## DISCUSSION ON “COMPETITIVE SORPTION OF MULTIPLE COMPONENT HEAVY METALS FROM GOLD MINING LEACHATE ONTO LATERITE SOIL” LOWLAND TECHNOLOGY INTERNATIONAL, 10(1), 54-64

Z. Li<sup>1</sup> and X. Tang<sup>1</sup>

Fig. 1 Isotherm of K(I) adsorption on Kaolinite determined by Batch Method and Soil Column Method

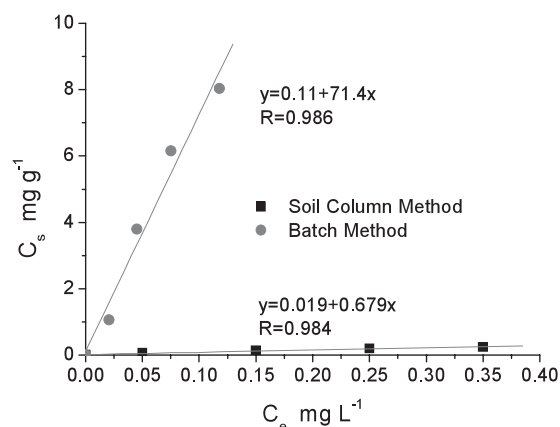
The sorption behavior of metals on soil determined by Batch adsorption method has been reported significantly deviated from that predicted by column diffusion test which proved more applicable to solute transport simulations (Khandelwal and Rabideau, 2000; Do and Lee, 2006). We have compared the sorption behaviors of potassium (K(I)) on pure Kaolinite mineral which was determined by different method and the adsorption isotherms are shown in Fig. 1. It is obvious that the sorption affinity ( $K_d$ ) obtained from Batch method is  $71.4 \text{ L g}^{-1}$ , much larger than  $0.679 \text{ L g}^{-1}$  that obtained from soil column method (Li et al., 2008). Similarly, this characteristic also exists in the sorption of heavy metals on clay minerals. Batch adsorption researches revealed that the solid-solution ratio has an obvious influence on the adsorption capacity of solute on the sorbent (Tang et al., 2008a; Tang et al., 2008b). In compacted soil, the solid-solution ratio is significantly greater than the dilute slurry used in Batch adsorption studies, which will inevitably affect the sorption behavior of solute. Therefore, those parameters determined by Batch method are not applicable in solute migration predictions in subsurface environment.
